### NSLPP MEETING HELD ON 06/09/23

**ADDRESS/WARD:** 20-22 Waruda Street, Kirribilli

**APPLICATION No:** 358/22

**PROPOSAL:** Alterations and additions to residential flat building to convert 27 strata titled flats into 7 apartments, landscaping and associated works.

**Figure 22: The view from viewpoint 1. The existing building is in yellow, and the proposed building is shown in blue. Visibility of the Opera House's sails is improved, and parts of the city skyline are in turn obscured and made visible. The net effect is acceptable.**

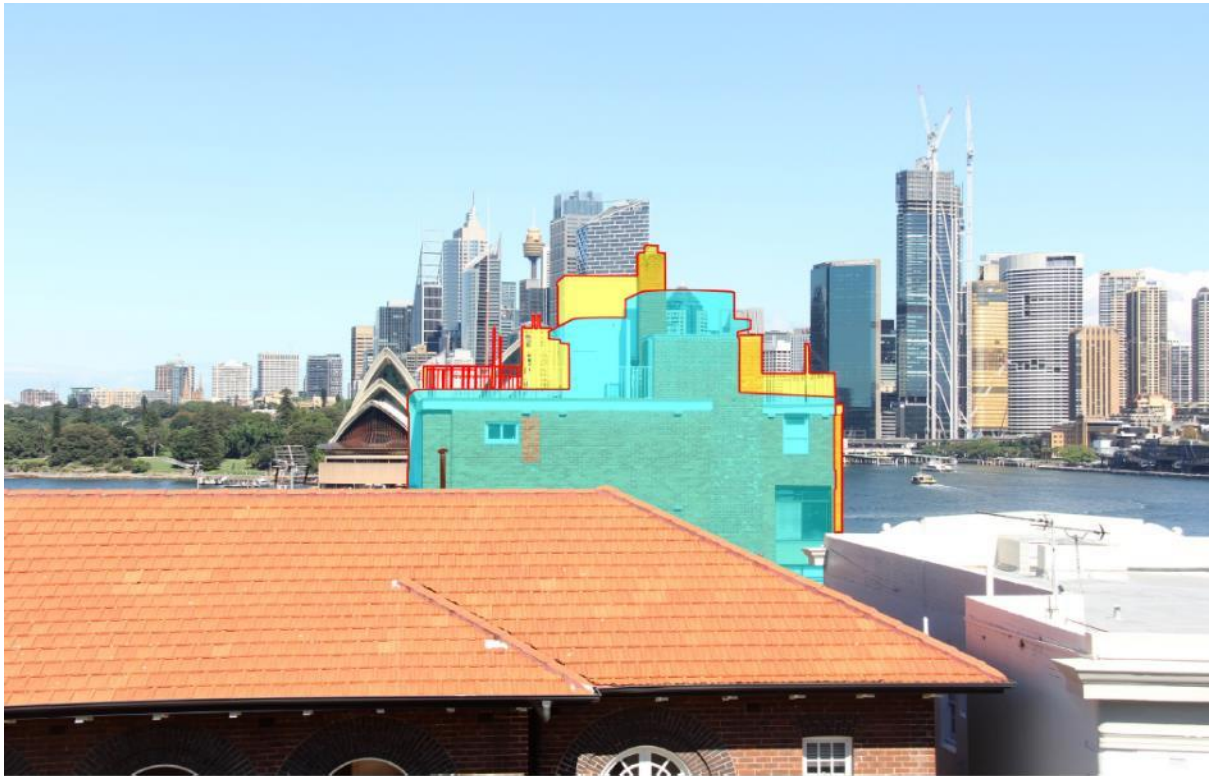
**Figure 23: The image allows comparison of the proposal (blue) with the existing building (yellow) from viewpoint 5. When viewed with the naked eye the existing white palisade fence around the subject building's accessible rooftop area is less prominent than shown by the yellow and red edging either side of the lift structure (tall yellow object). In terms of built form, a taller object is replaced with a slightly lower and wider object. The sky view is reduced and the view of the Royal Botanic Garden, less-so. The net impact is marginal.**

**Figure 24: From viewpoint 11, the proposal has a slightly improved view of the Opera House, as the rooftop element is lower and narrower than previously proposed. The alterations have little effect on the overall vista, mainly due to the distance between the viewpoint, the subject building and the prime elements of the vista. One submission noted that the Opera House and City appear closer than indicated, to the naked eye this true. The above image appears to have been corrected, to reduce the distortion caused by the original image being taken with a wide-angled lens.**

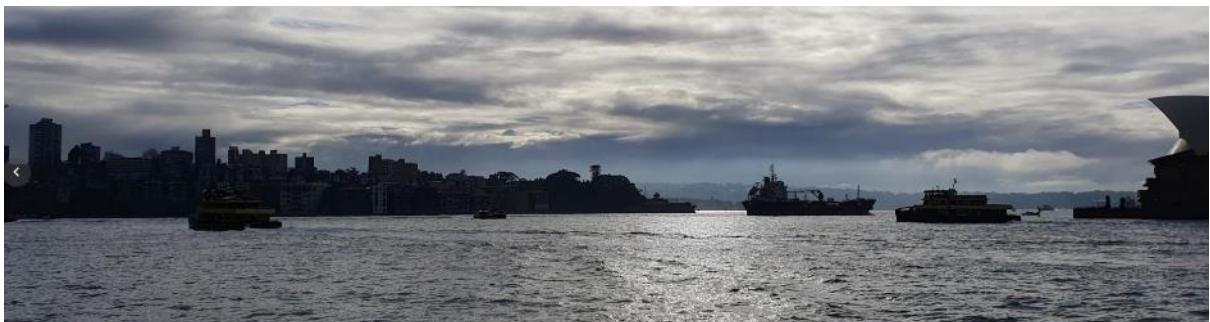
***Figure 26: From the Opera House, and in a brighter light, individual buildings become apparent. Toward the centre of the image, the subject building can be identified by the blue lift structure on the roof. Although a dark photo, the colours of the existing building blend in, and the contrasting effect of white balconies and windows is clear. The prominence of the off-white building on the shore and left of the subject building, is evident. As discussed, if all buildings visible in this image were of similar white to pale grey hues, they would collectively compete, and not contrast with, the Opera House.***

***Figure 27: Again, the subject building is marked by its blue lift structure, seen against the backdrop of the trees in the grounds of Admiralty House and Kirribilli House. This view is from the Harbour Bridge's pedestrian walkway, almost due west of the site. Comparing the proposed colours with those of other buildings in the locality, the proposal is compatible with its surrounds. If the predominant off-white cladding originally proposed for the western and eastern façades remained, the building would contrast strongly with the tones of most nearby buildings, contradicting the DCP controls for the Kirribilli Heritage Conservation area, and those of the Opera House Buffer Zone of the Eastern Harbour City SEPP.***
